# Human Factors Evaluation of Control Room Design and Operator Performance at Three Mile Island - 2

Final Report

Three Mile Island Special Inquiry Group

U.S. Nuclear Regulatory Commission

**FIGURE 3**  
**PILOT OPERATED RELIEF VALVE (PORV) PANEL**

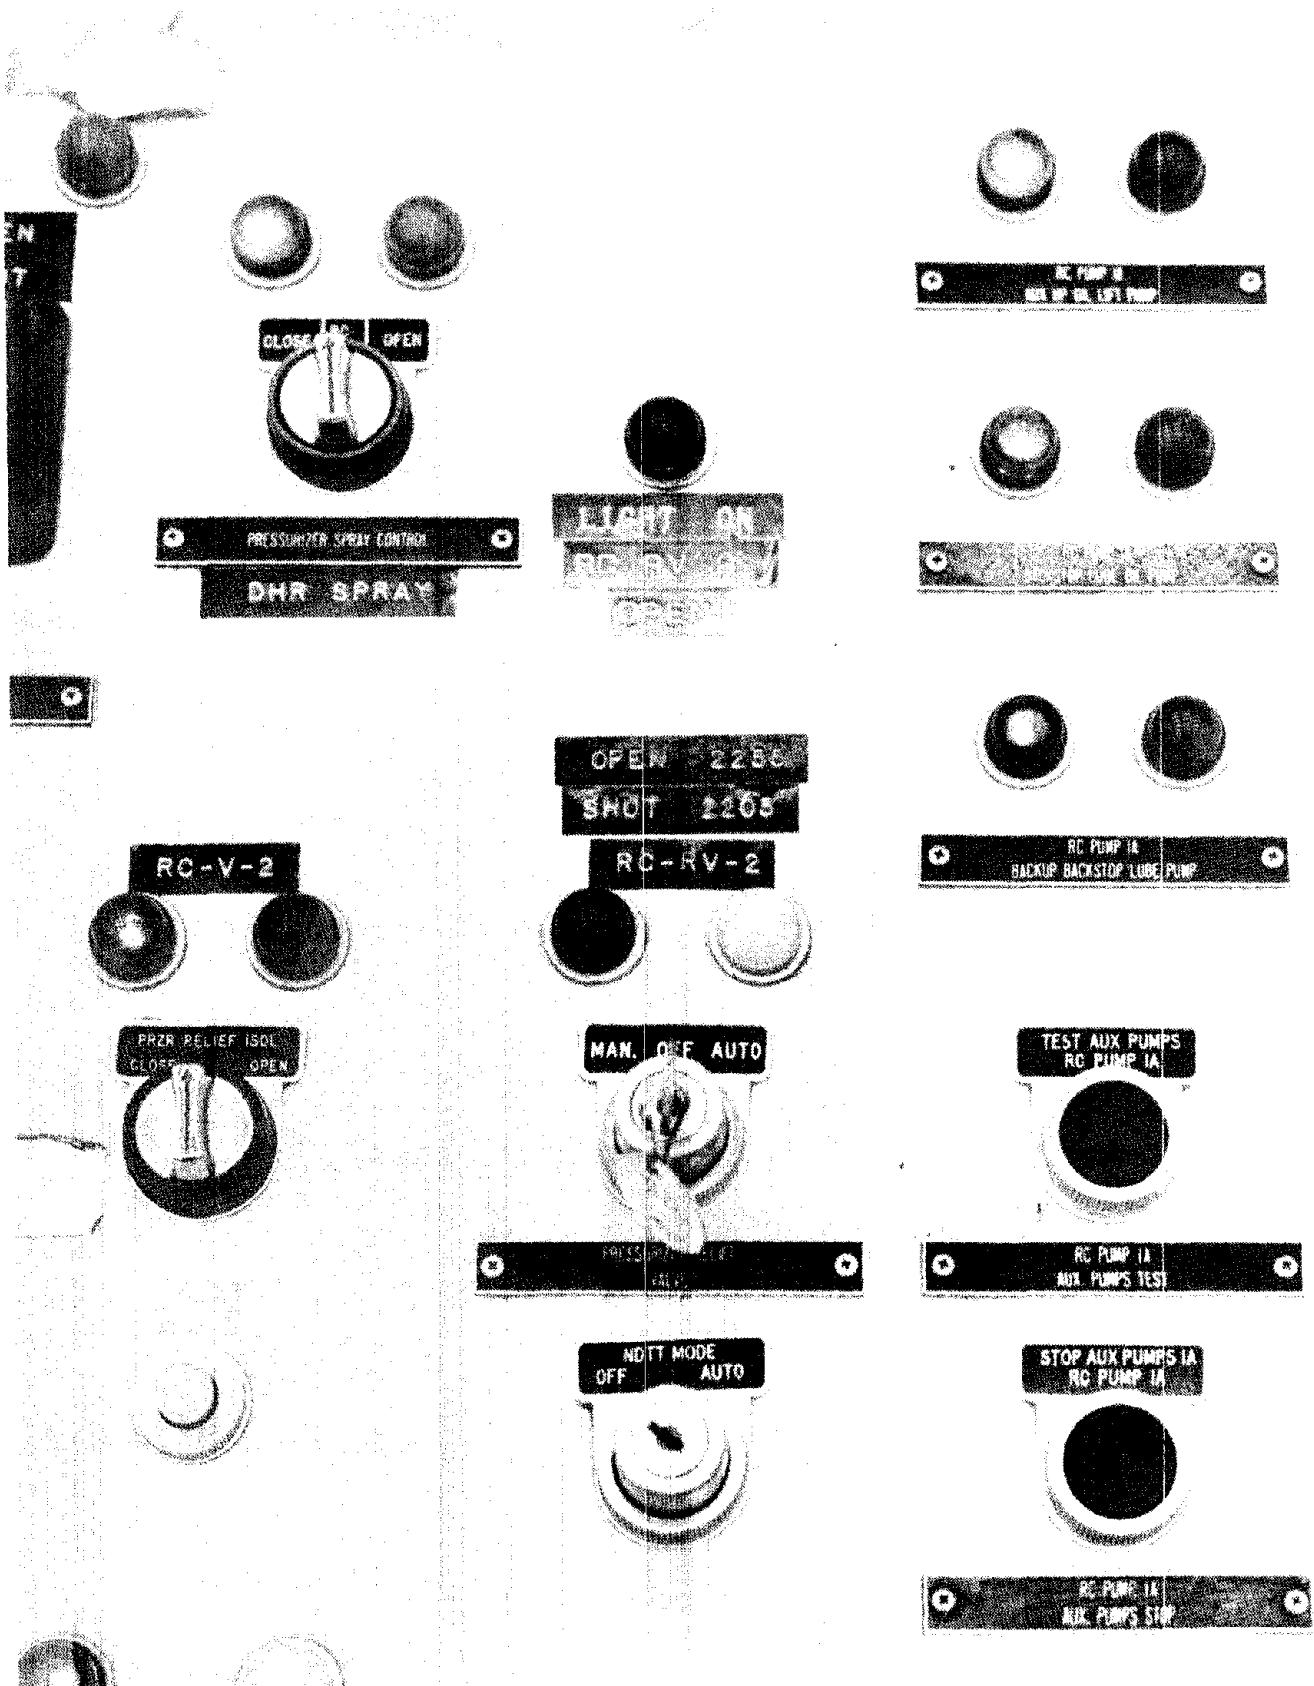
- Invalid Information. The PORV status indicator is a single red light located on Panel 4. The light is designed to come on when an electrical signal is transmitted to the PORV to open, and go out when a signal is transmitted for the valve to close. As indicated in Figure 3 the light is labeled "Light on — RC-RV2 open." This design is a violation of basic HFE principles as referenced by the following provision of MIL-STD-1472B, paragraph 5.2.2.1.4. "The absence or extinguishment of a signal or visual indication shall not be used to

- Labeling. As indicated in Figure 3 the PORV indicator panel has several operator added labels, which reflects the inadequacy of the original labeling approach. Label nomenclature is not consistent with procedures which refer to RC-V2 as the electromagnetic relief isolation valve rather than the pressurizer relief isolation valve (EP 2202-1.5, page 1).

**FIGURE 4**  
**EMERGENCY FEEDWATER CONTROLS AND DISPLAYS**

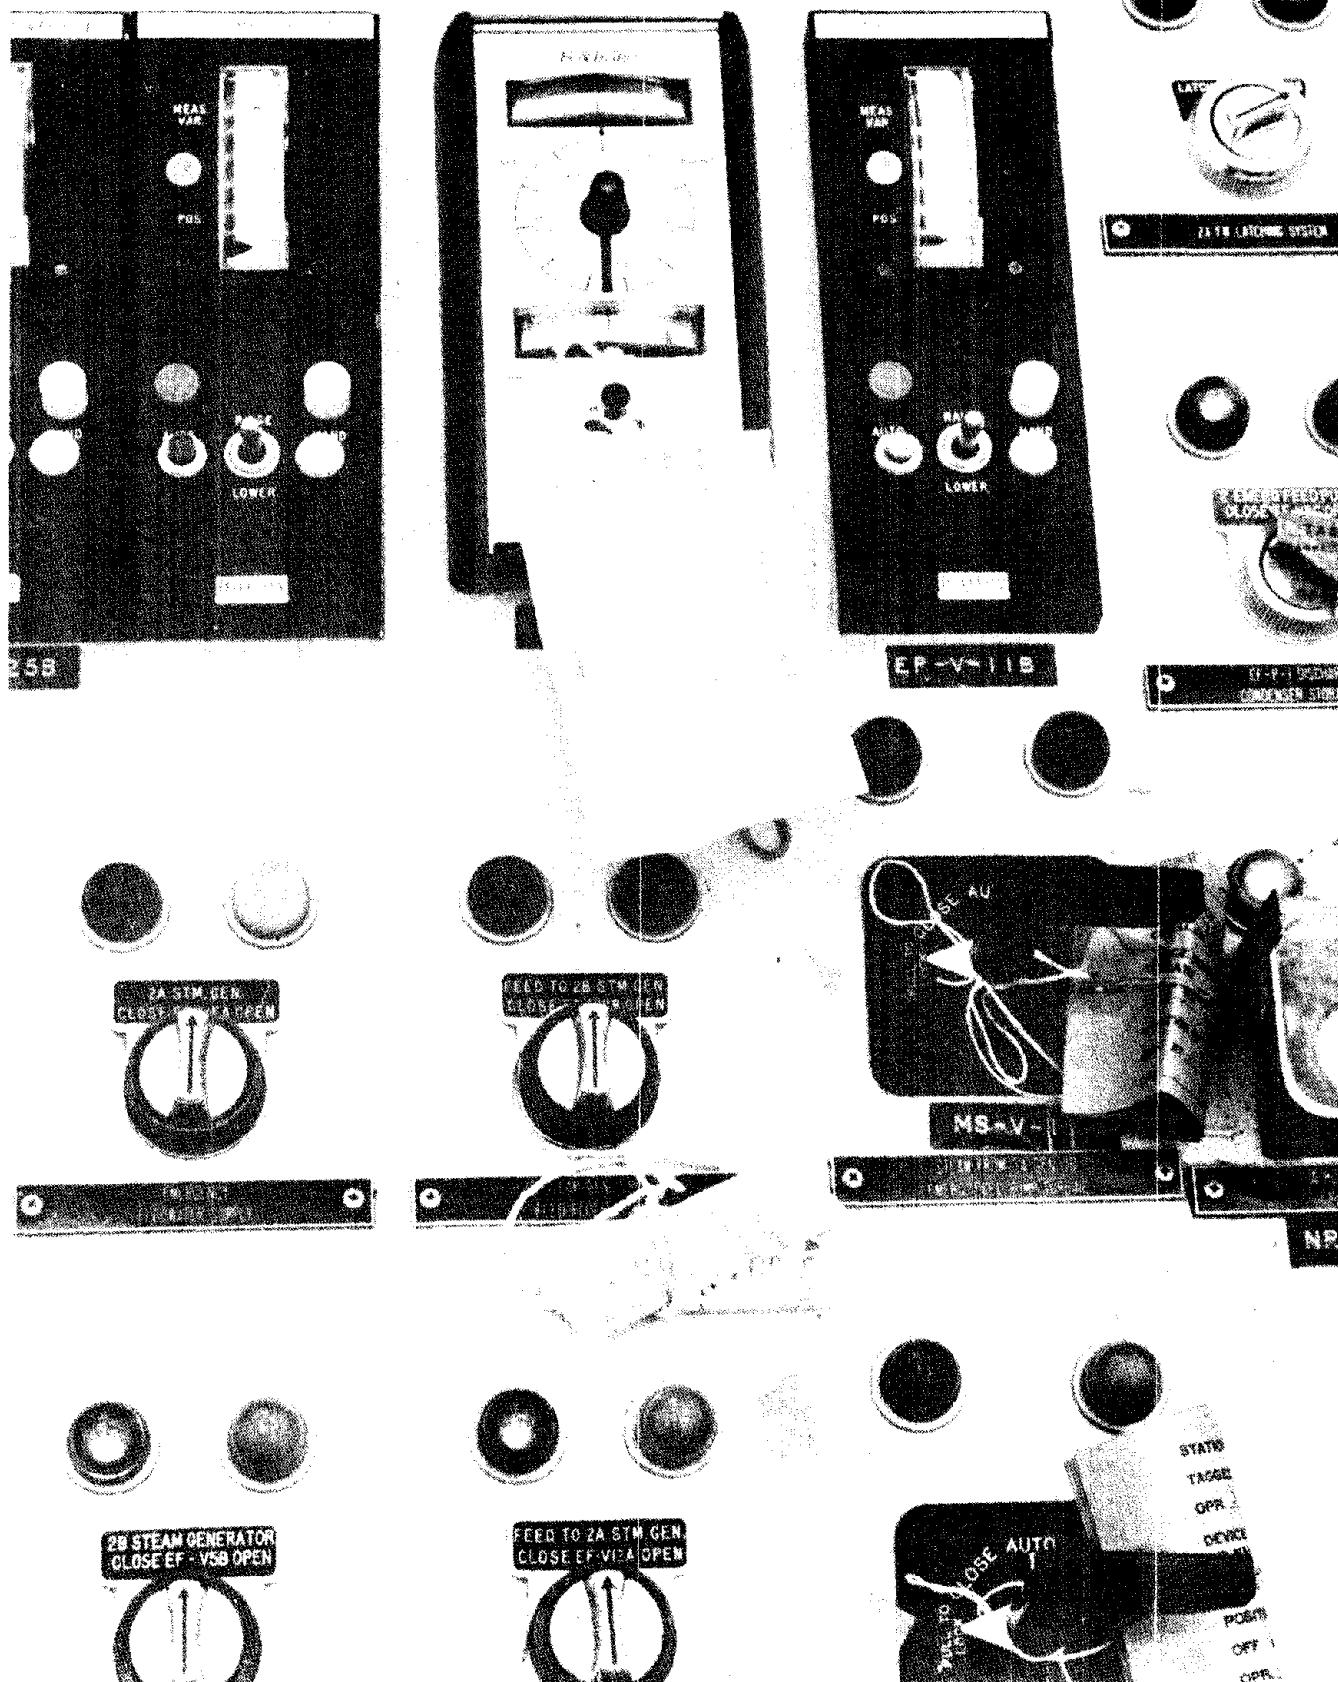
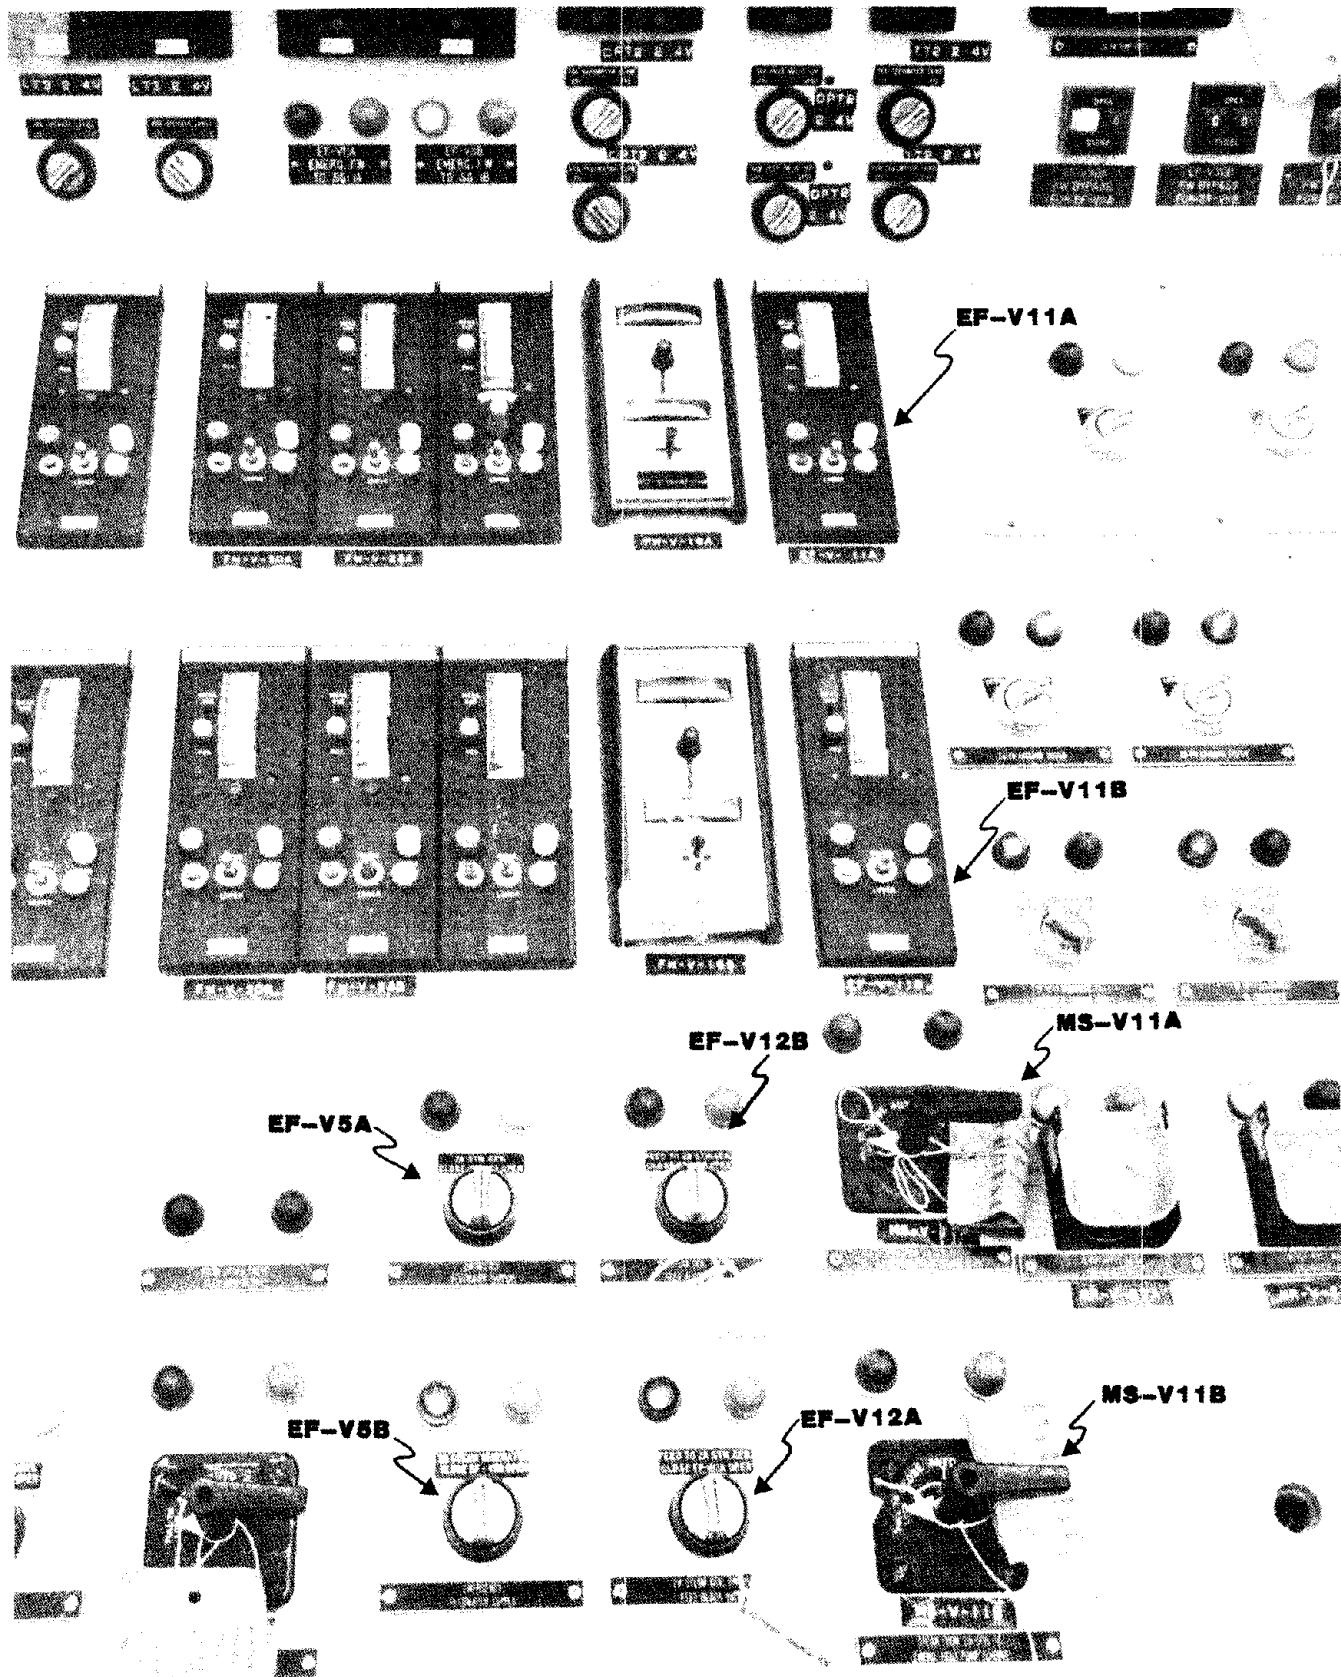
There is no displayed indication or alarm to indicate that the emergency feedwater system is in a misaligned or inoperative condition. The operator must visually inspect pump status and valve alignment to confirm that the system is functioning properly.

- Workstation Design/Panel Layout. The feedwater panel is not laid out in a sequential or otherwise logical fashion (i.e., mimic). Control and display placement on the panel is inconsistent; as indicated in Figure 5, "A" loop components are placed above "B" loop components

(e.g., emergency feedwater control valves 11A and 11B), in other cases "A" loop components are placed below "B" loop components (e.g., feed water header isolation valves 12A and 12B). In still other cases, "A" loop and "B" loop components are placed side-by-side (e.g., feedwater latching system). There are two pairs of controls labeled 11A&B (EF-V11A&B and MS-V11A&B) located one on top of the other. The arrangement of system A and B controls is haphazard with EF-V5A, EF-V12B, and MS-V11A all side by side. Control-display relationships are not obvious or consistent. For example, indicator lights for the emergency feedwater control valves are placed on the vertical panel of the console several inches to the left of their associated controls.

**FIGURE 7**  
**EXAMPLE TMI-2 ANNUNCIATOR PANEL**

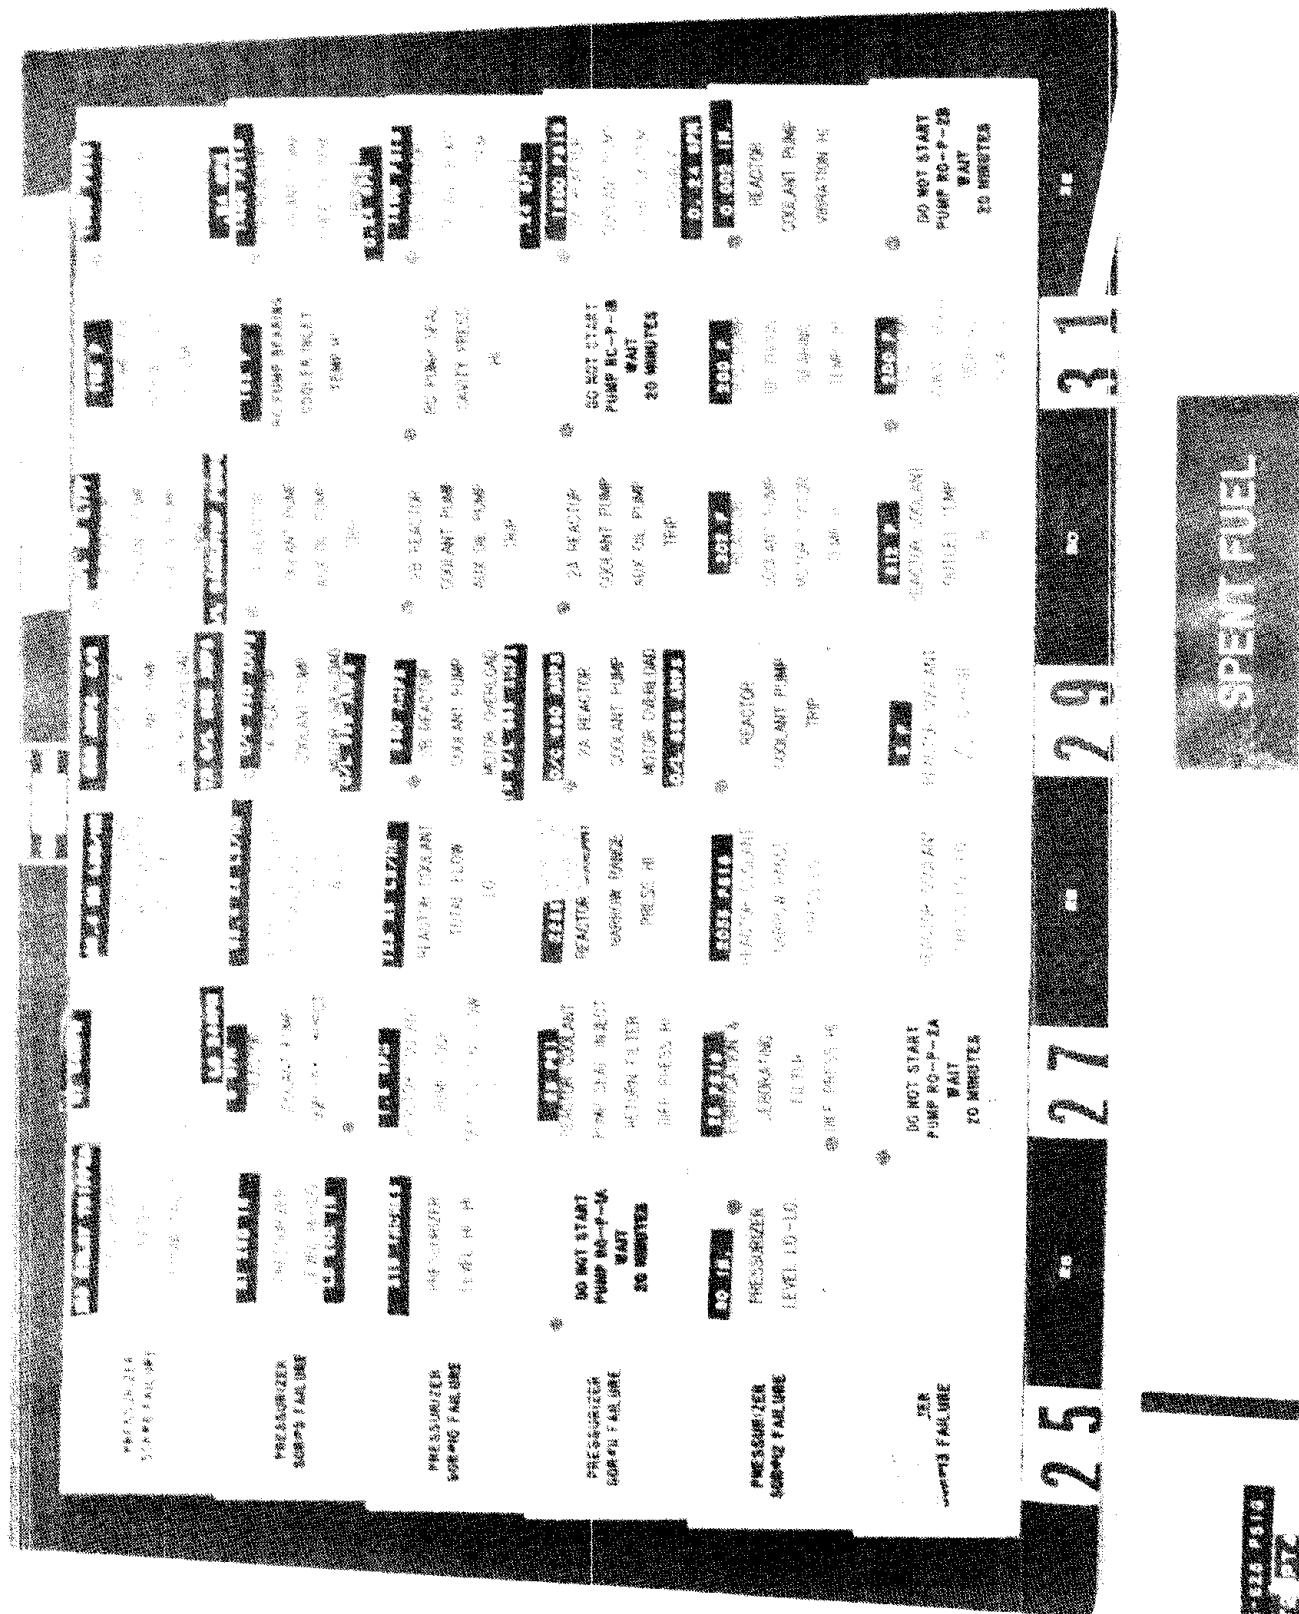
- The annunciator system, which includes over 750 annunciator lights (some of which are outside the main operating area, e.g., RCDT panel), is poorly organized, both in terms of grouping and relationship of alarms to associated subsystems. In addition, critical alarms have not been color coded or otherwise prioritized to permit immediate identification. In many cases, legends are excessively wordy or contain inconsistent abbreviations, increasing the time required to ascertain their meaning (see Figure 7).
